KWM-380 TRANSCEIVER (622-5093-101)  
HF-380 TRANSCEIVER (622-3580-101)  
RECEIVER-EXCITER CIRCUIT CARD A3 (638-6908-001)

SERVICE BULLETIN NO 1

PRODUCT IMPROVEMENT

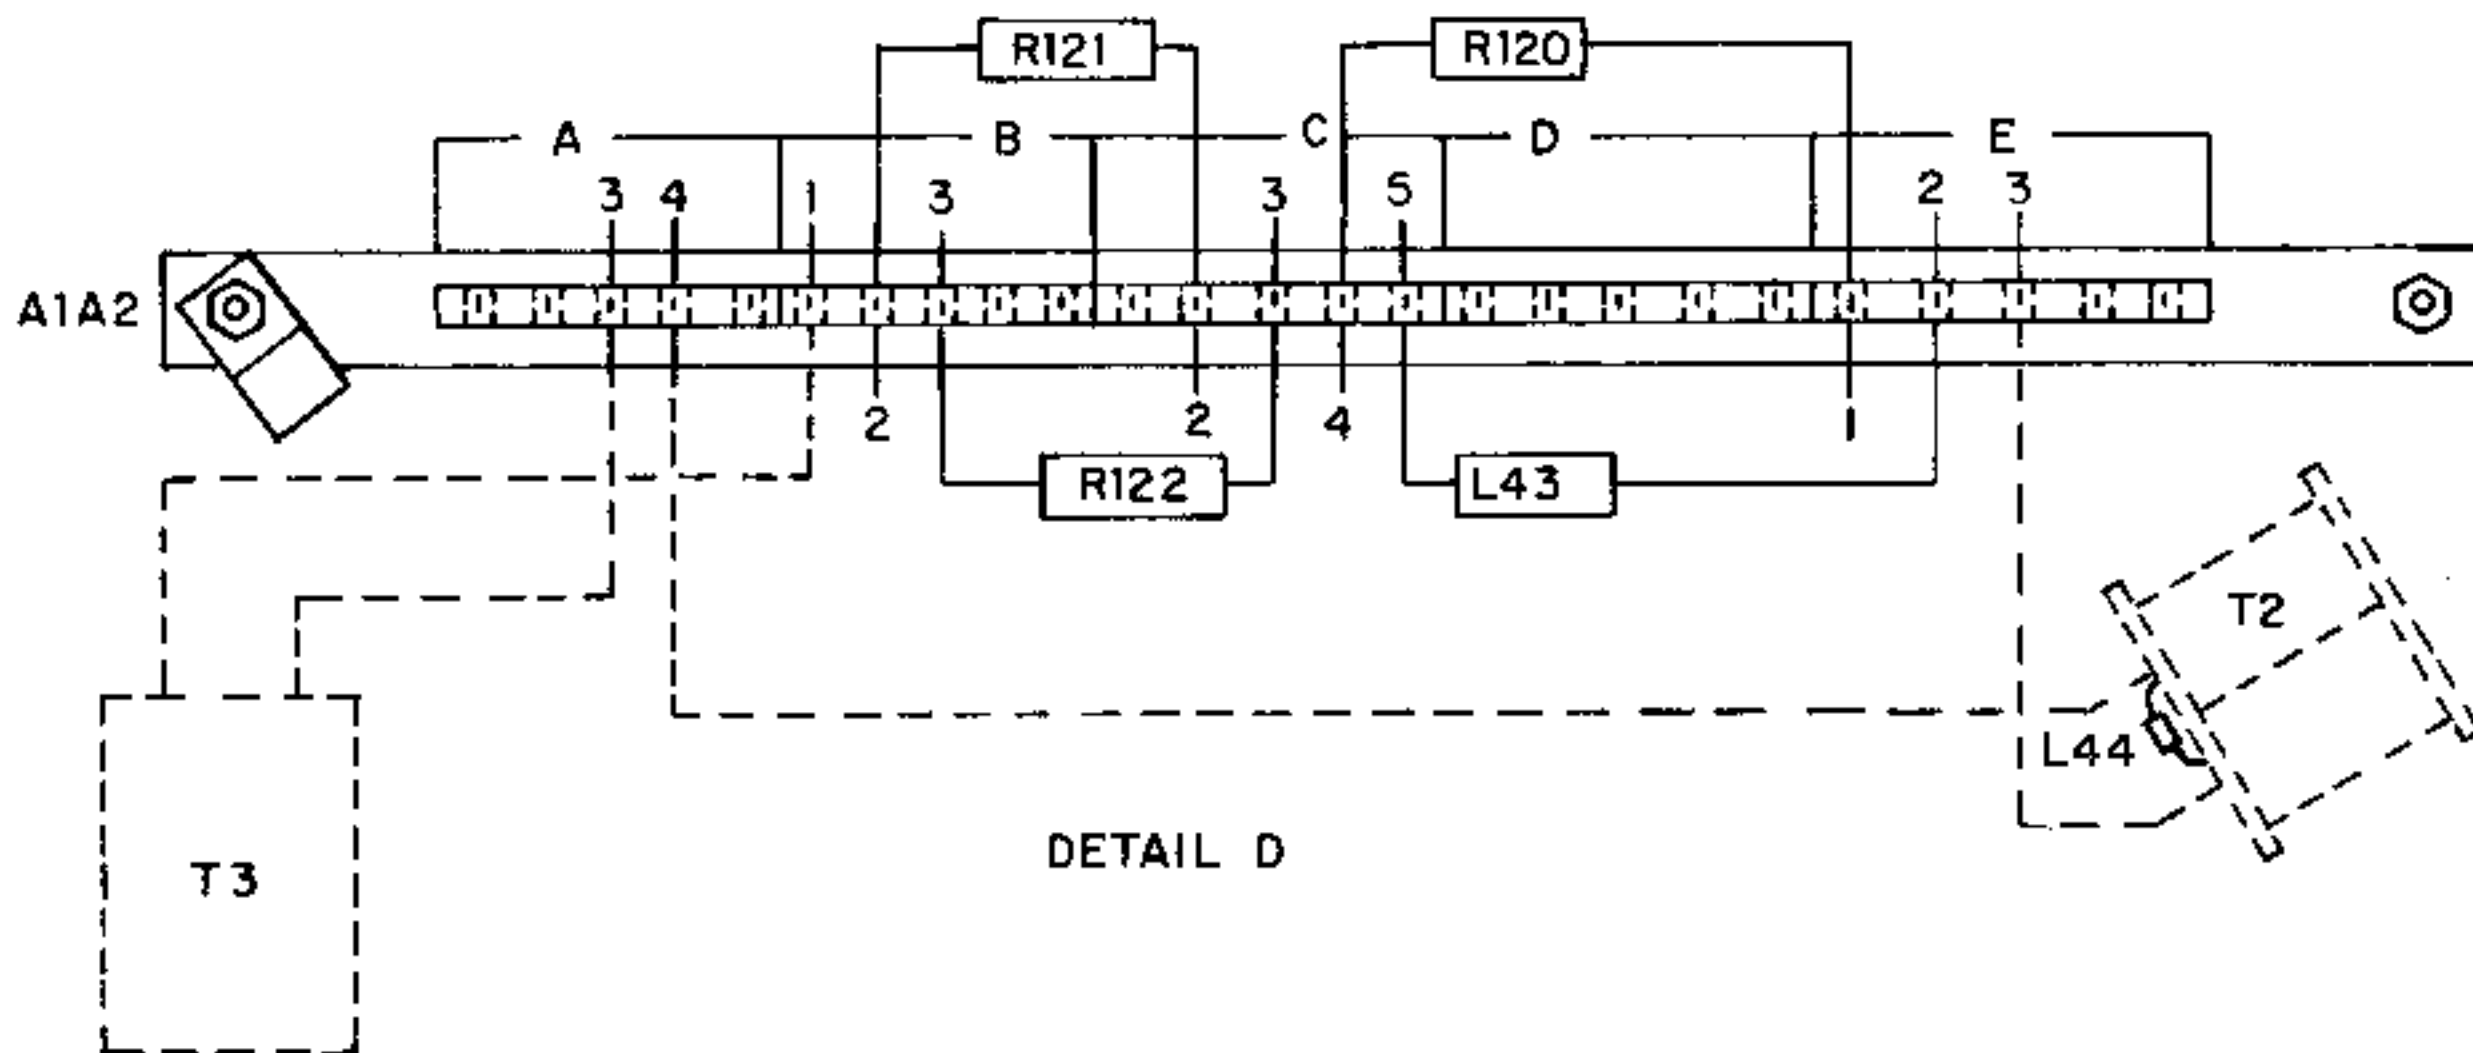
NOTE: Do not remove circuit card A1A1 from power amplifier/heat sink assembly A1. Refer to figure 1 while performing steps E through T. Refer to figure 2 for a schematic diagram of the latest configuration.

- E. Remove 1500-pF capacitor C55 by cutting the leads close to the body of the component. Leave the capacitor leads soldered into the circuit card.
- F. Install a 1000-pF capacitor (912-3315-000), connecting the leads to the leads of the capacitor removed in step E.
- G. Install a 2.7- $\mu$ H coil L44 (240-2715-180) as shown in figure 1, detail A.
- H. Remove 0.27- $\mu$ H inductors L23 and L24 by cutting the leads close to the component body. Leave the inductor leads soldered into the circuit card.
- I. Install two 3.3- $\mu$ H inductors (240-2029-000), connecting the leads to the leads of the inductors removed in step H.
- J. Install 100- $\Omega$  resistor R123 (745-1310-000) in parallel with L23. Wrap the resistor leads around the coil leads and solder.

- Q. Remove and discard 68- $\Omega$  resistor R116.
  - R. Install electronic components assembly A1A2 (647-2781-001) onto the circuit card as shown in figure 1 using the existing hardware.

- S. Wind two turns of brown wire (422-0795-000) in transformer T3 as shown in figure 1, detail B. Connect to A1A2 assembly as shown in figure 1, detail D. If the transformer core has potting in the holes, carefully clear a way for the brown wire, using a stiff wire such as a straightened paper clip.

- T. Wind two turns of red wire (442-0796-000) in transformer T2 as shown in figure 1, detail D. If necessary, clear the core of potting as in step S.

- NOTE: The added wires in steps S and T must be oriented as shown in figure 1, details B and C, to prevent oscillation.
- U. Reassemble the transceiver in the reverse order of disassembly.

NOTE: LEADS FROM T2 AND T3 MUST BE CAREFULLY POSITIONED AS SHOWN TO PREVENT DESTRUCTIVE OSCILLATION.

Low-Pass Filter Card A15  
Figure 2

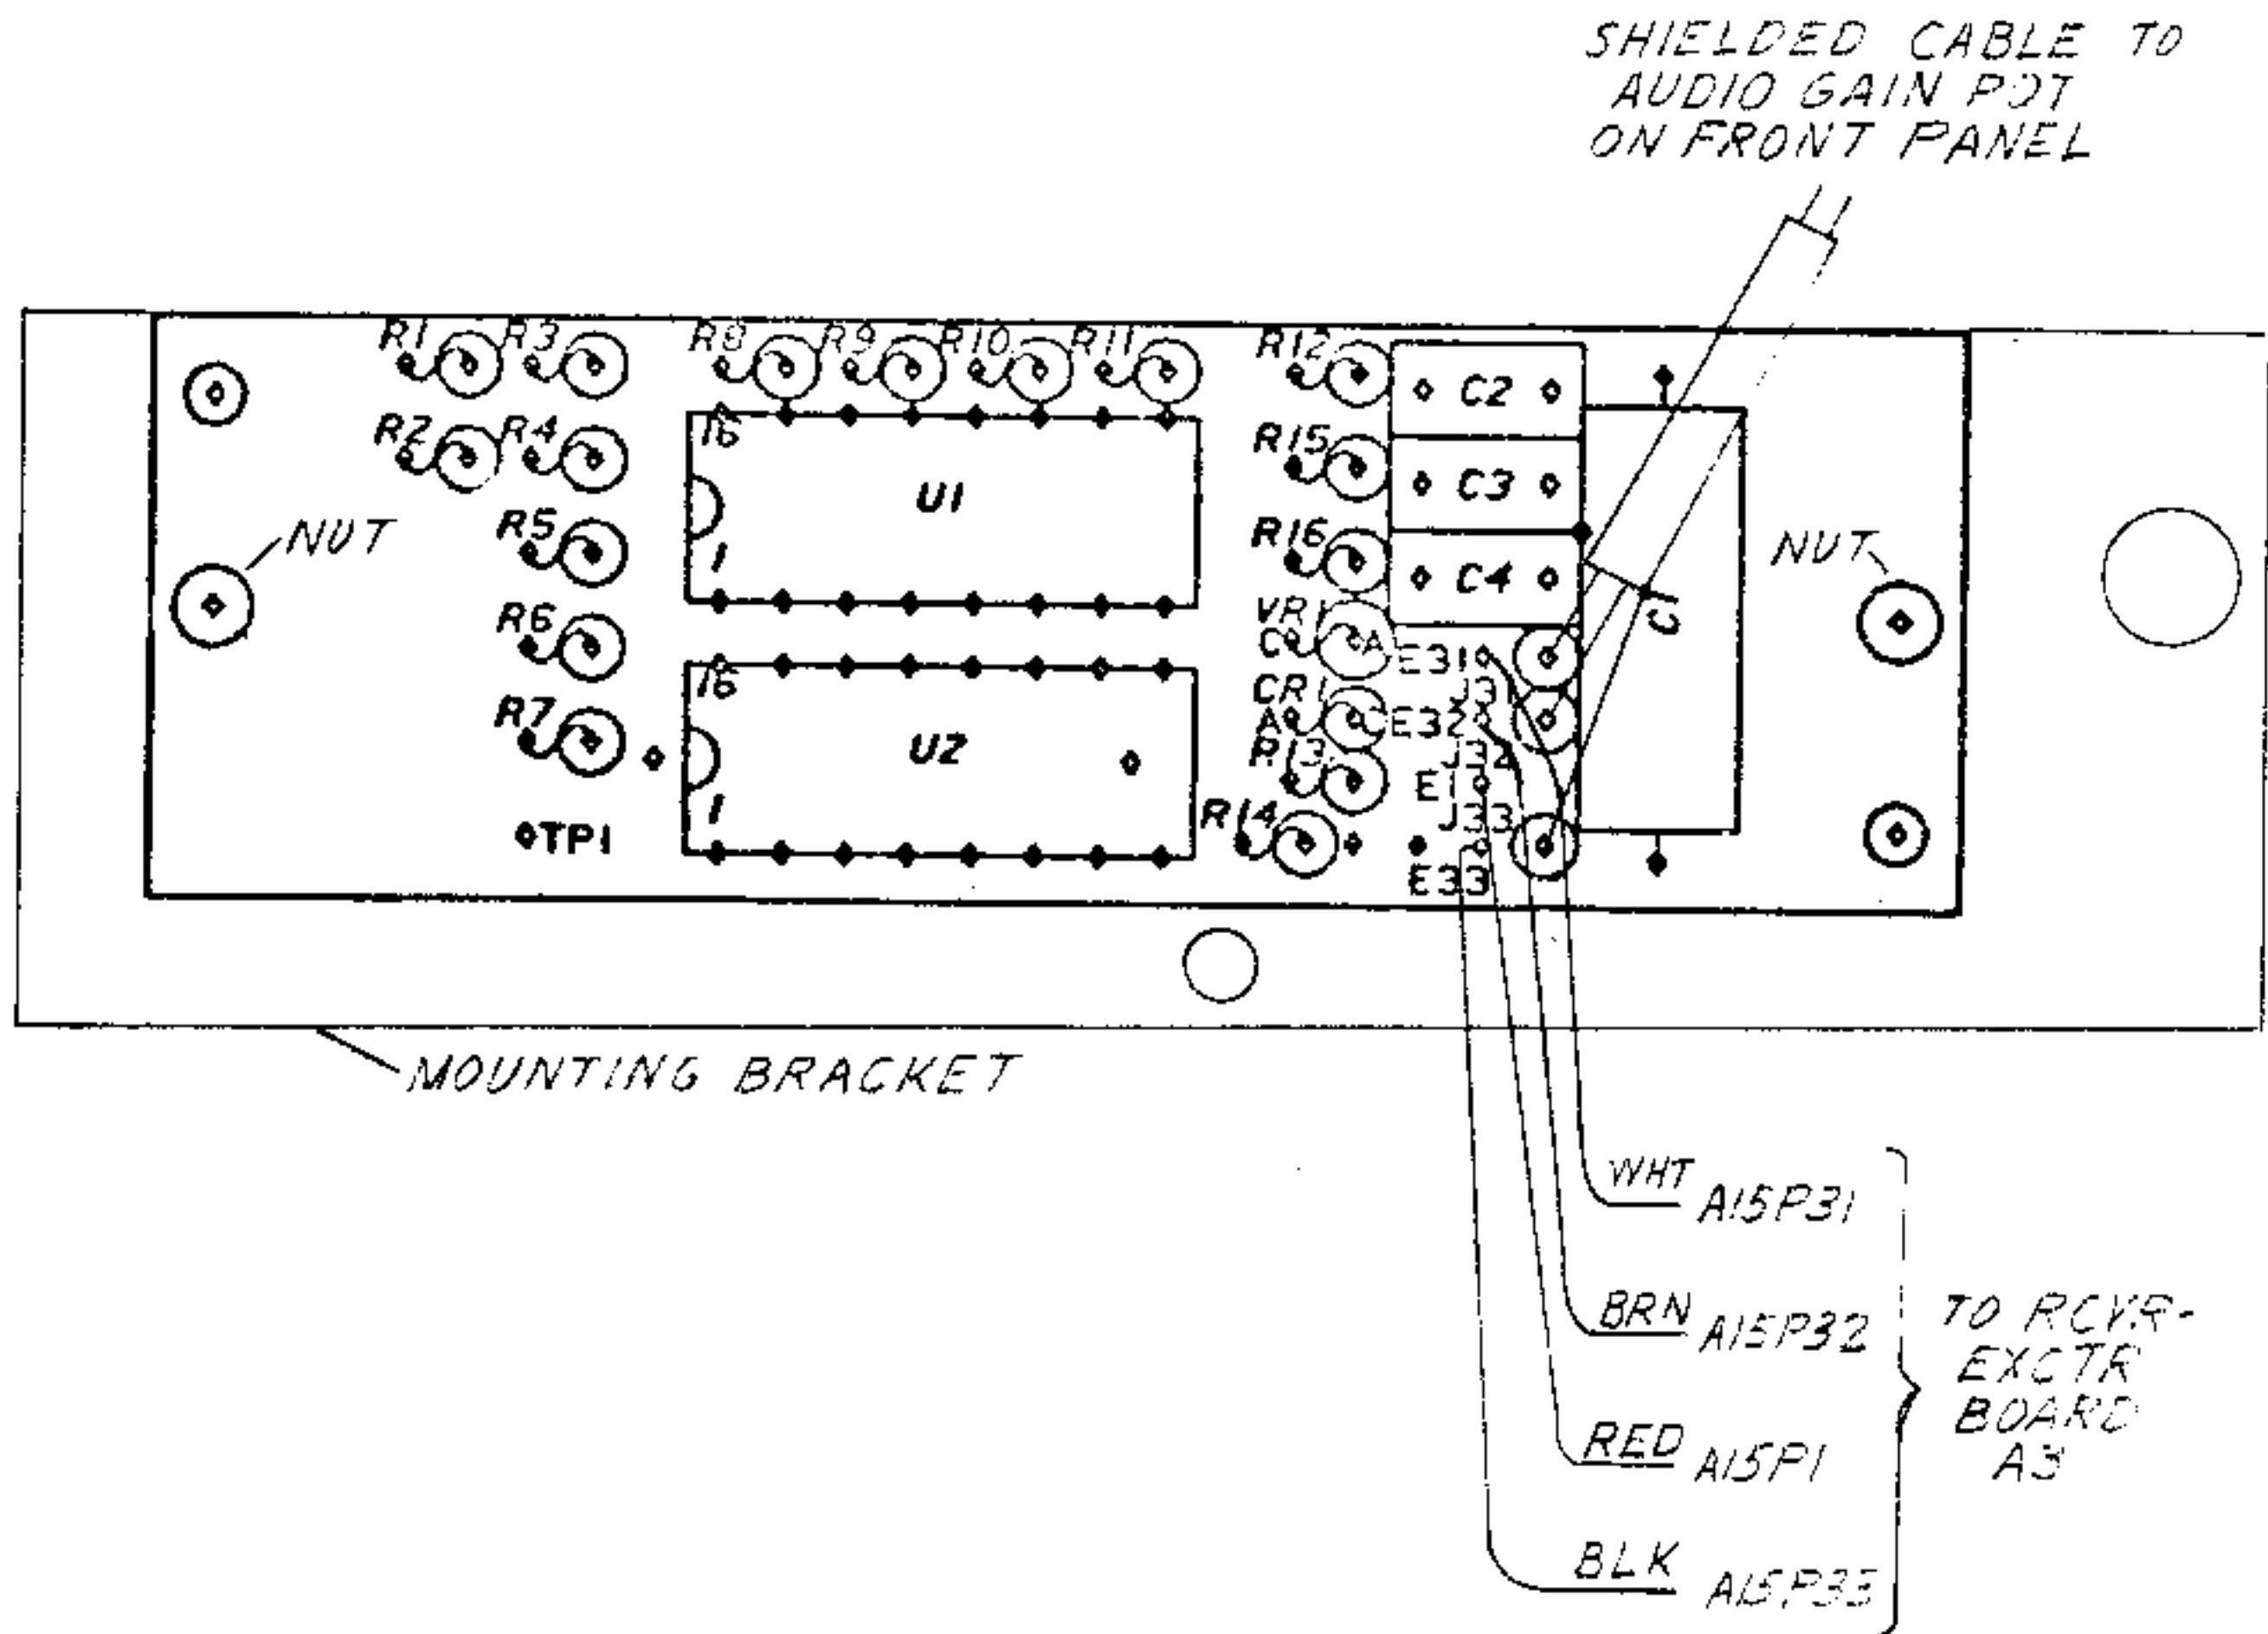
- D. Install filter circuit card A15 (646-5802-001) onto mounting bracket (647-2929-001) using two hex nuts (333-1299-000). Refer to figure 2.

P/O Receiver-Exciter Card A3  
Figure 3

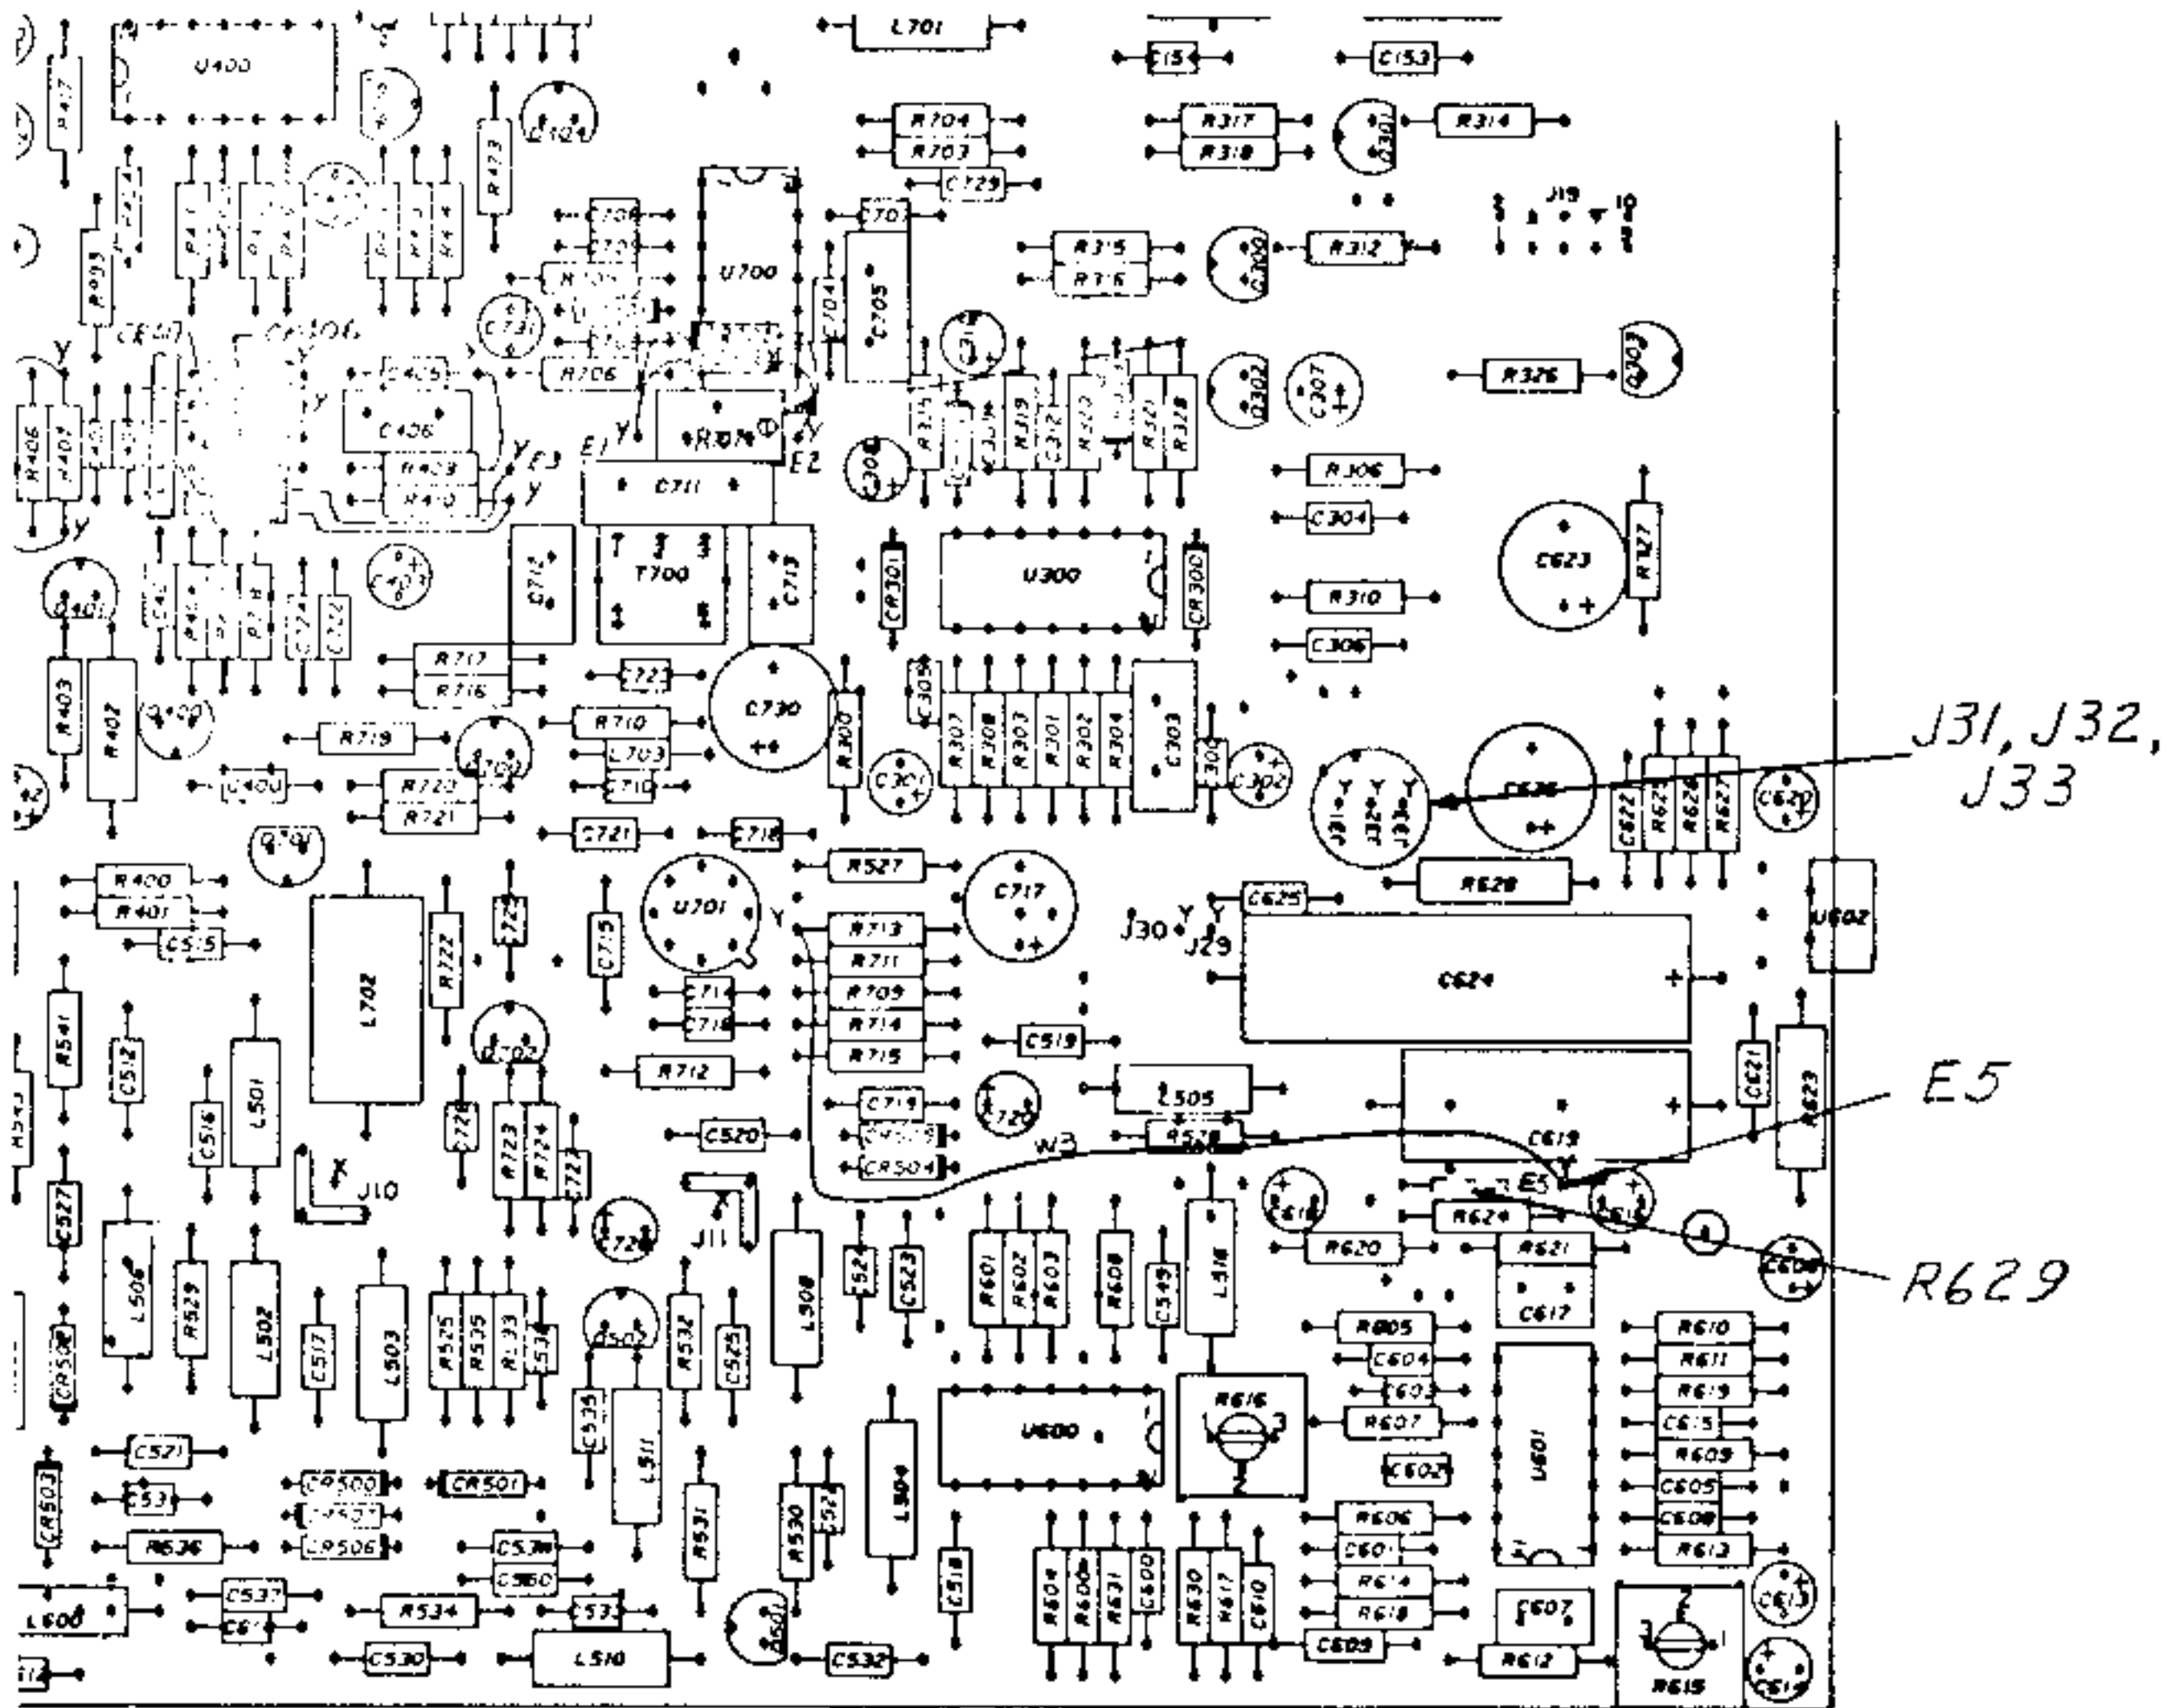
- G. Inspect receiver-exciter card A3 to determine if W3 is connected from R713 to E5 as shown in figure 3. If this wire has been installed, proceed to step N. If W3 is not present, perform steps H through M.
